Project Name: Mt. Hope School – New BuildProject No.: 221125-140Architect: C2AEDate: 7/31/2023Bid Package No.: 2Bid Due Date: 08/03/2023

Addendum 3

Project No.:	22-0116	Date:	July 28, 2023
Project:	Mt. Hope Lansing School District SB-1785 Ingham County, MI	A/E Firm:	C2AE
Owner:	Lansing School District 519 West Kalamazoo Street Lansing, MI 48933	Project Manager:	Steve Jurczuk

PLUMBING PLAN - AREA A
1/8" = 1'-0"

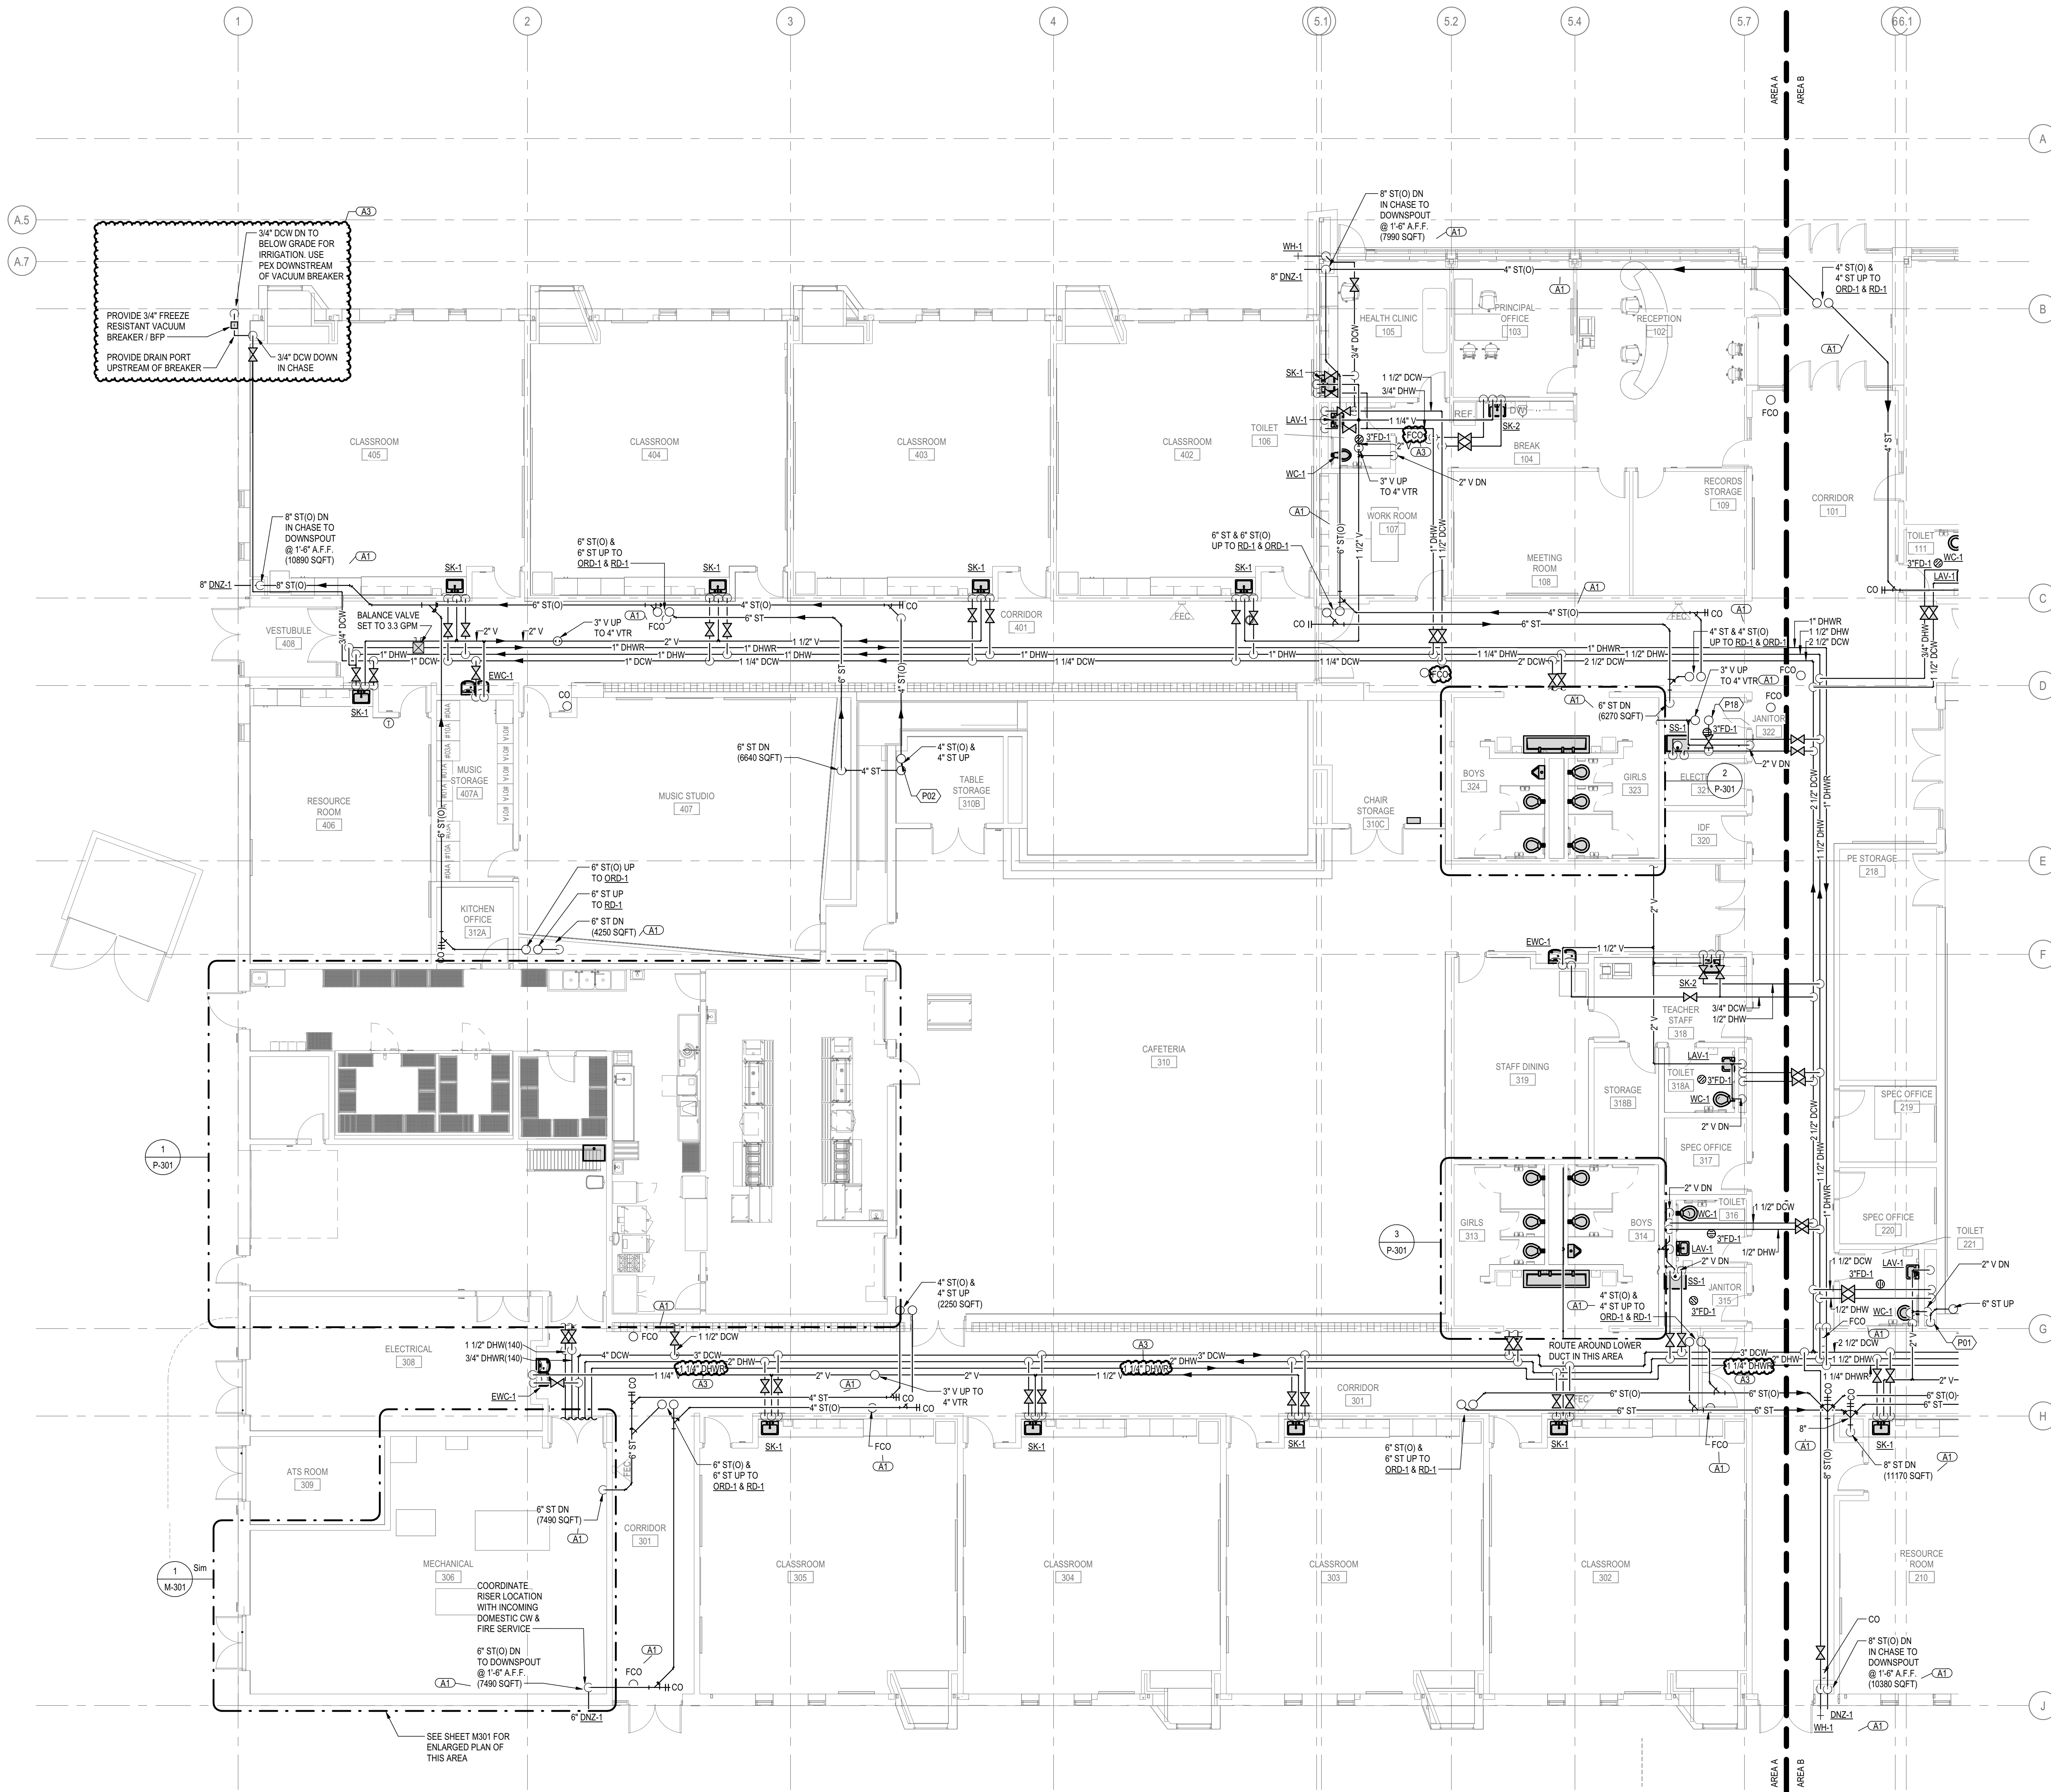
1. Revise DCW piping near room 405 and provide irrigation components as indicated.
 2. Tag floor cleanouts as FCO.
 3. Revise DHWR line size in Corridor 301 as shown.

WATER SAVER TRAP PRIMER DETAIL (TP-3)
SCALE: NONE

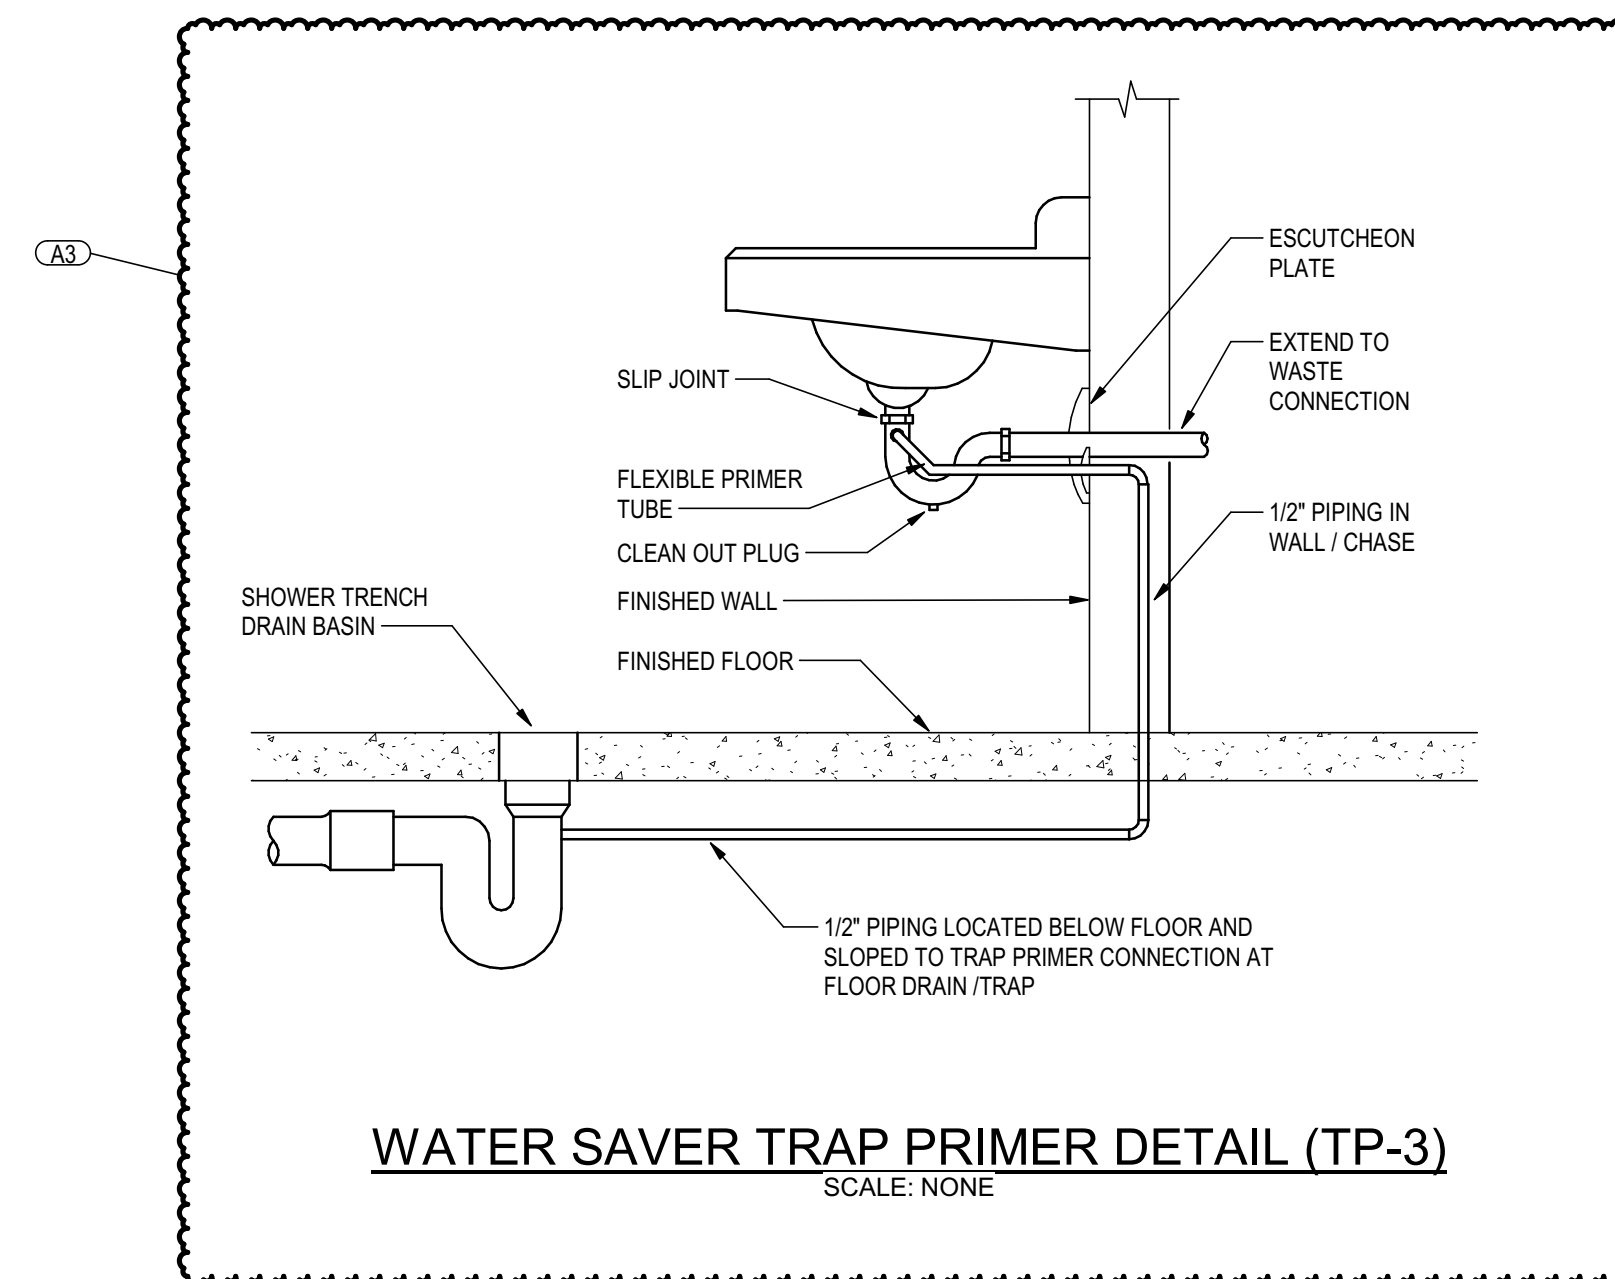
1. Add water saver trap primer detail.
 2. Change title of multiple trap primer detail as indicated.
- A3.25 Refer to Sheet M-111B (reissued):
1. Revise keynote SM07 verbiage as indicated.

SITE PLAN KEYNOTES

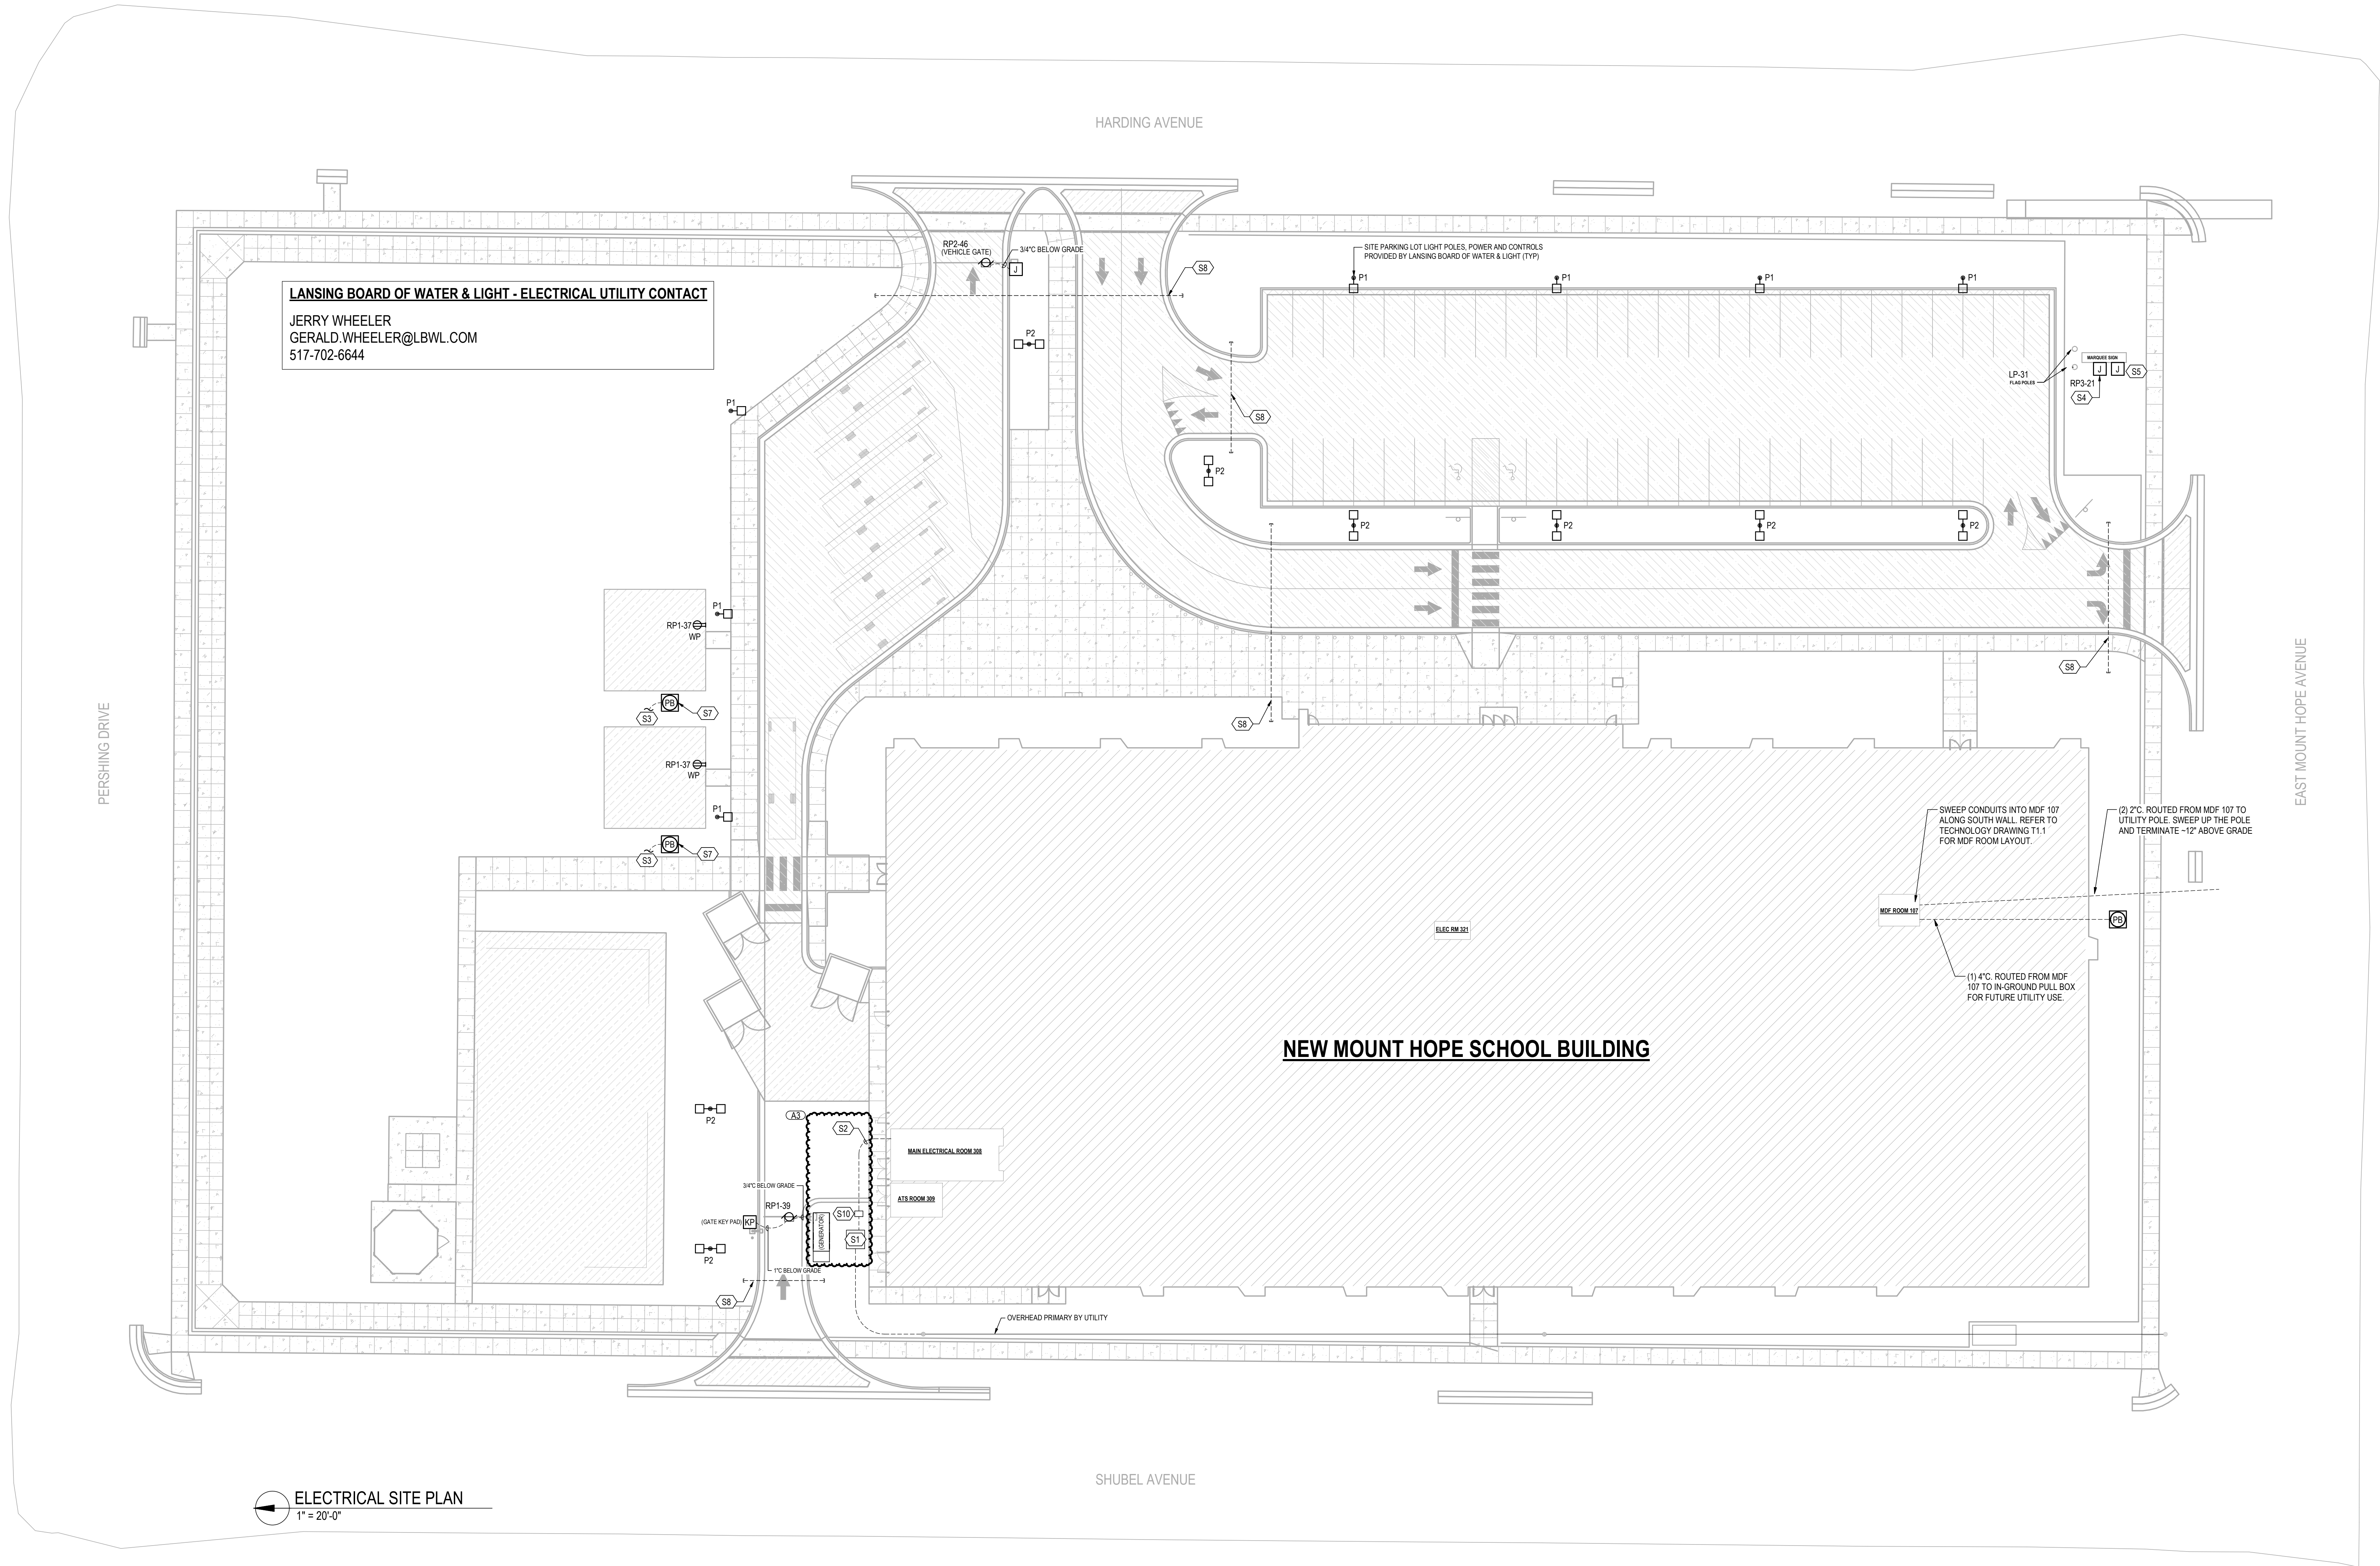
- A3.29 Refer to Sheet M-701 (reissued):
Add VFD / ECM Motor Control Diagram.
- A3.30 Refer to Sheet ES01 (reissued):
Revise layout of site electrical distribution equipment.
